CARRIER, INSTALLATION, FULL TRACKED, MKs 2 AND 2/1 (FV439)

MODIFICATION INSTRUCTIONS AND INDEX

MODIFICATION INSTRUCTION NO. 1

SUBJECT: EMER TV E107/9 Modification Instructions No. 1 to No. 8

Fig 1 Cover plate

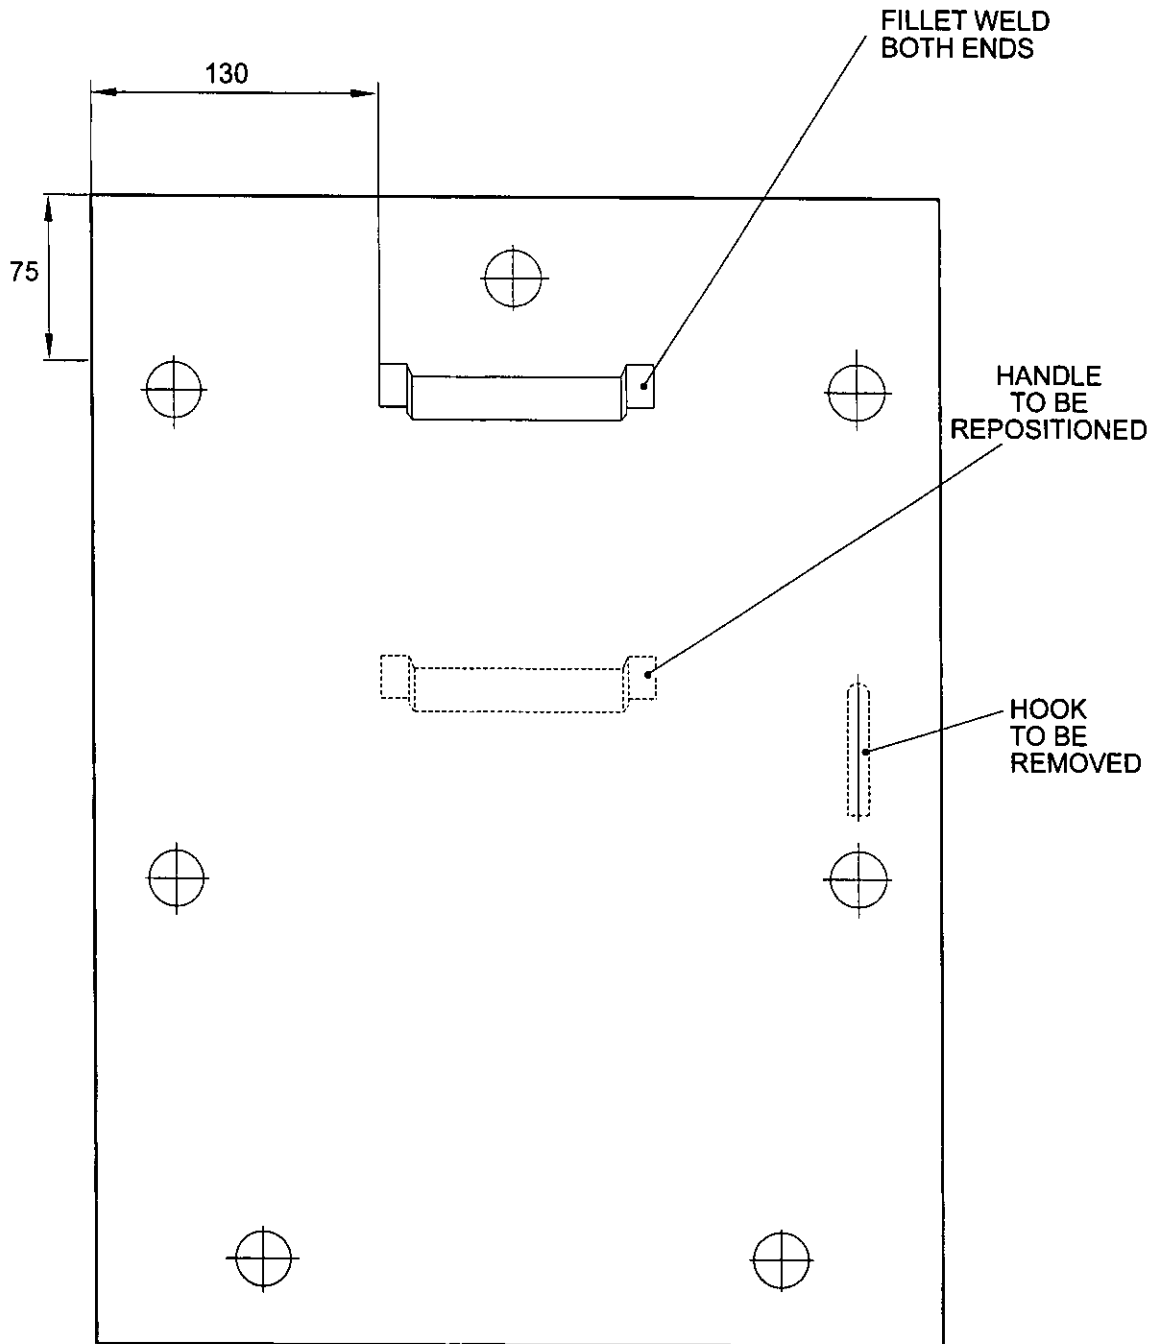
9.1 Remove cover plates (item 13) from front of engine cover. Remove and discard the hook. Carefully remove, reposition and re-weld the handle to the cover plate. Welding to be carried out to current regulations. Repeat for the second cover plate. Restore paint finish to current regulations. Refit cover plates (item 13).

Fig 2 Cover assy (lower)

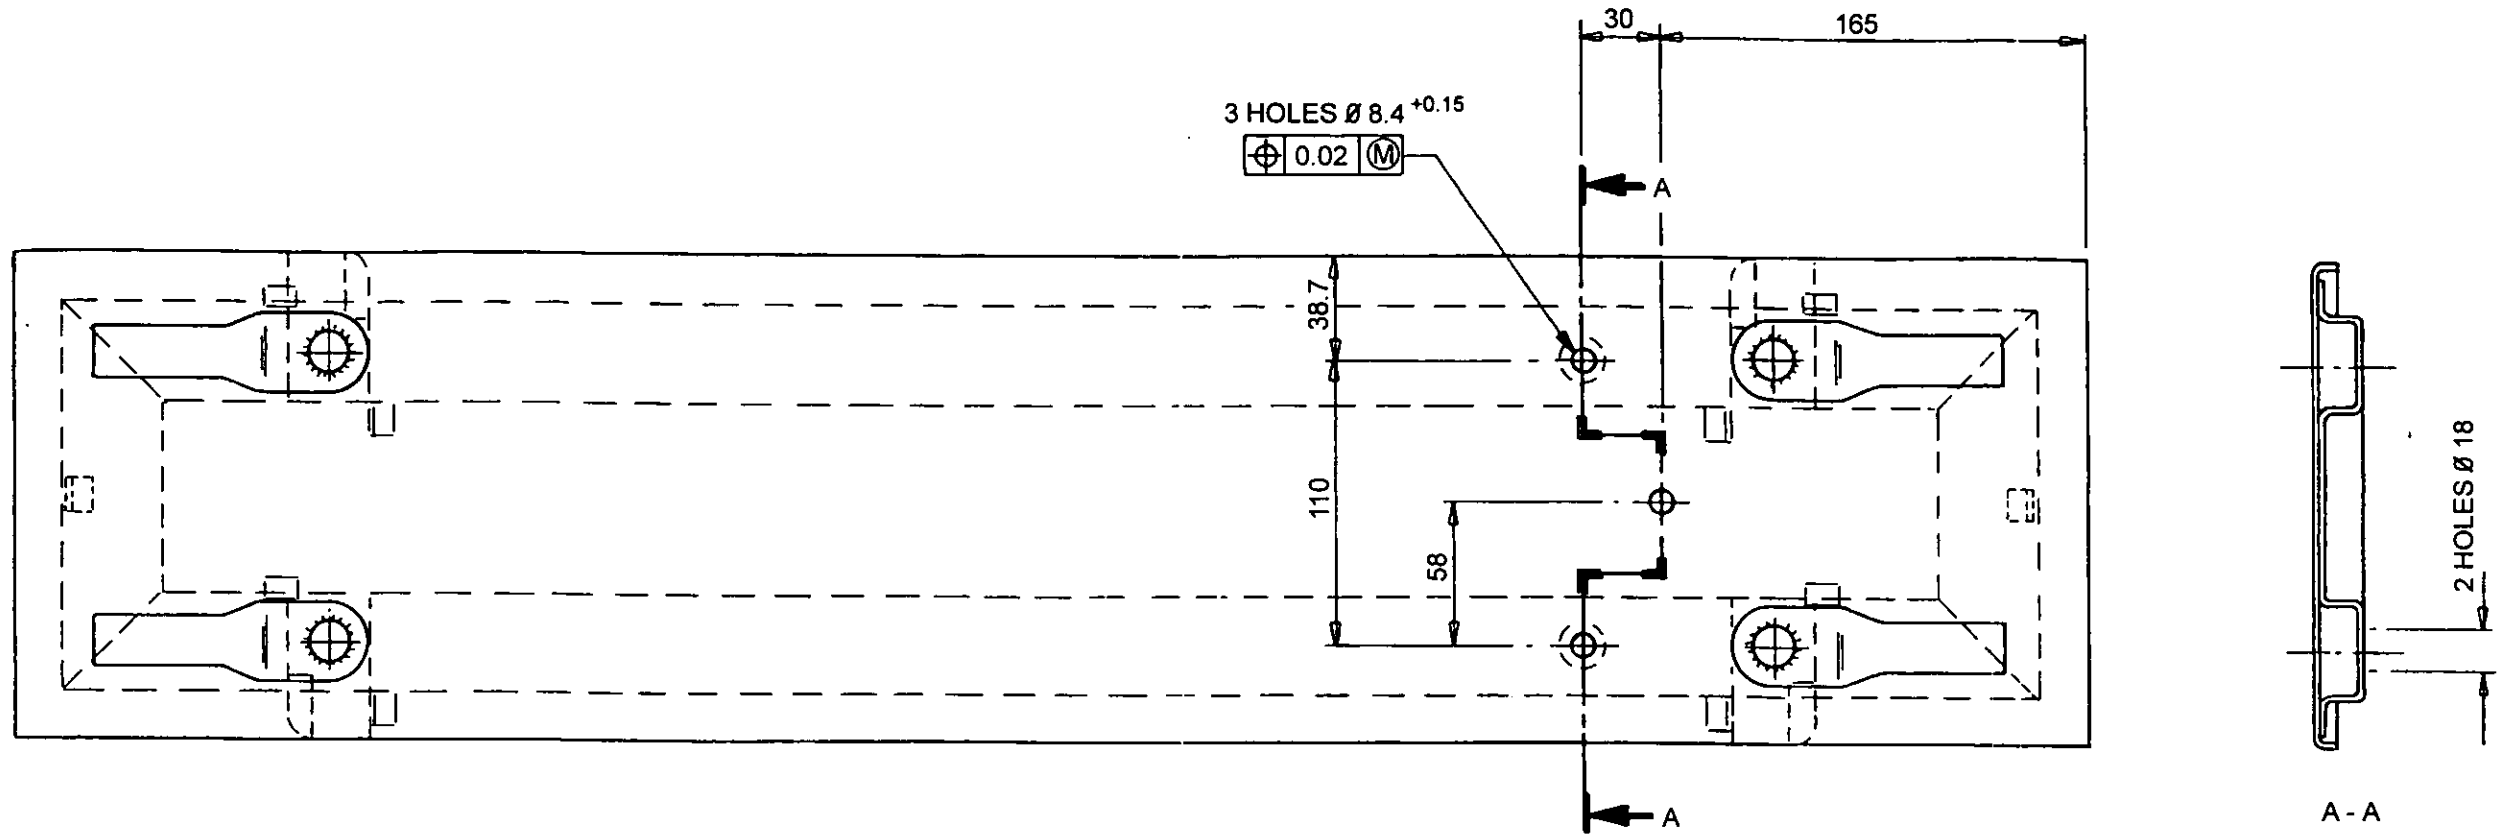
9.2 Remove cover assy (item 12) from engine cover. Mark out and drill holes in cover assy. Restore paint finish to current regulations.

Fig 1 Catch Mechanism Side View

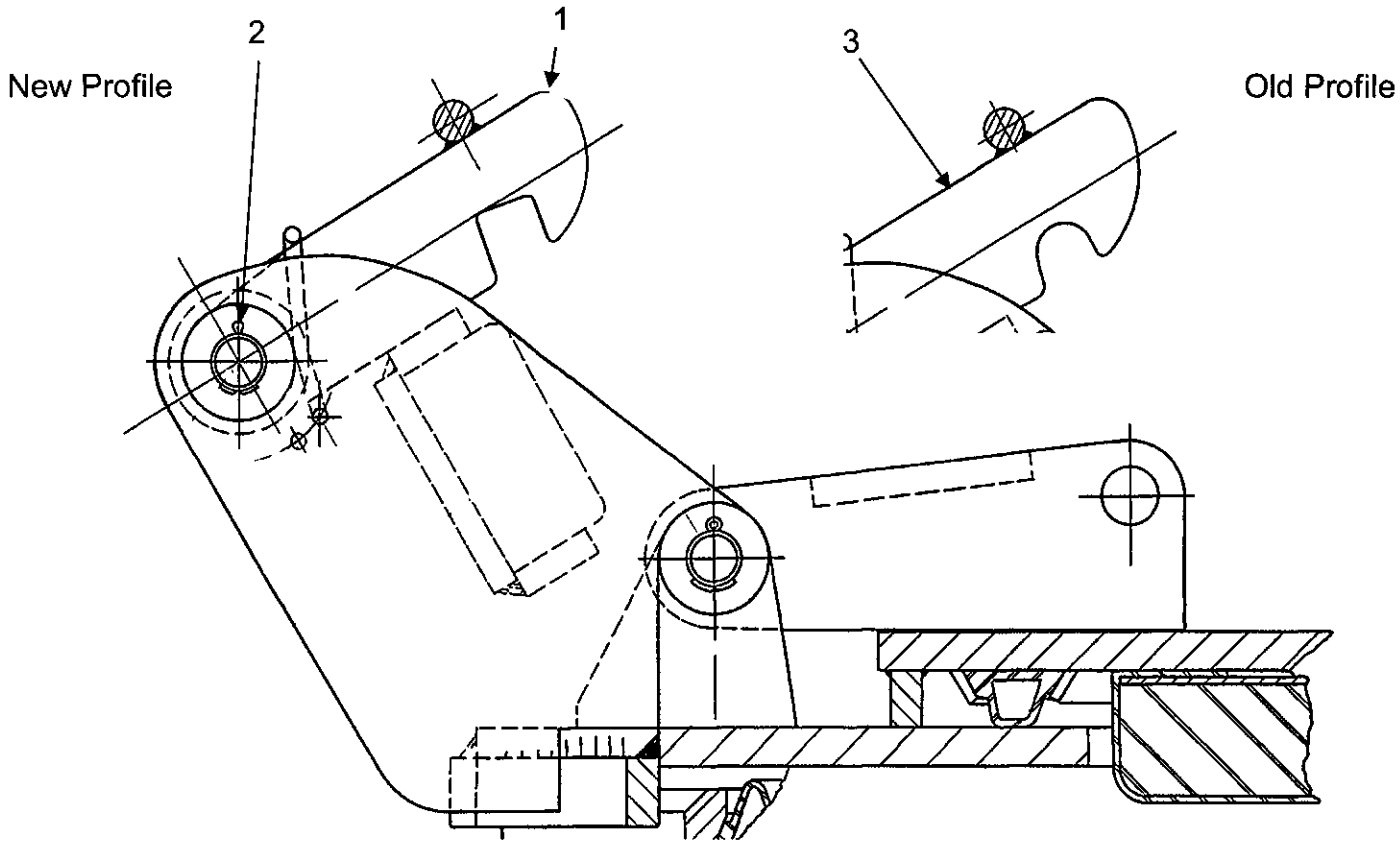
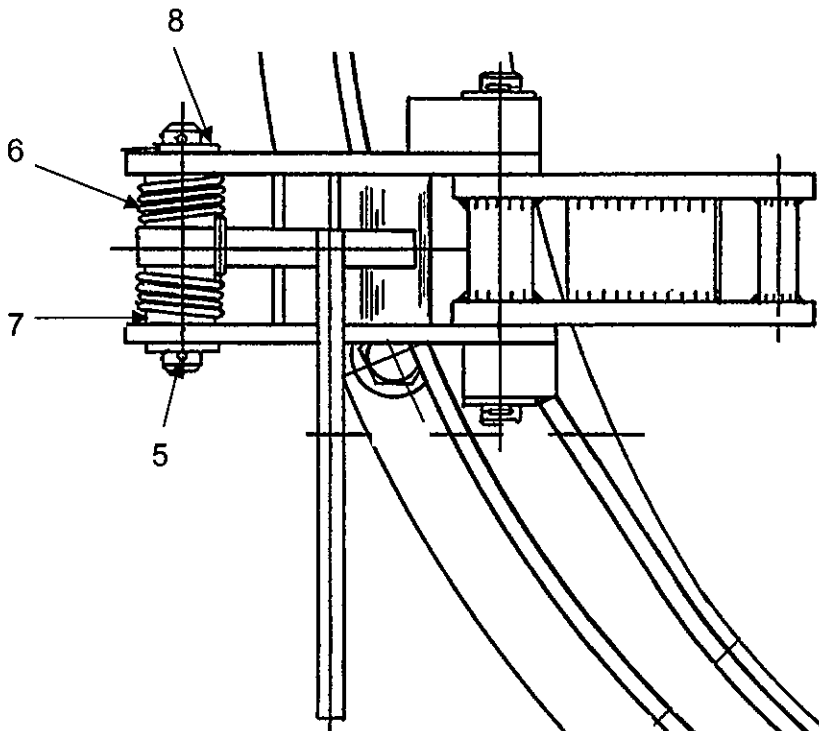
1 As a result of serious equipment failure when the commander's hatch locking arm (catch) failed to lock in the open position, causing injury to personnel, a modified catch is introduced.

9.1 With the commander's hatch in closed position remove split pin (4) and washer (8) from one end of pin (5). Remove pin together with torsion spring (6), distance pieces (7), commander's hatch catch (3) and washer. Discard split pin and commander's hatch catch.

9.2 Refit torsion spring (6) and distance pieces (7) and fit replacement commander's hatch catch (1), securing in position with pin. Refit washer (8) and replace split pin (2).
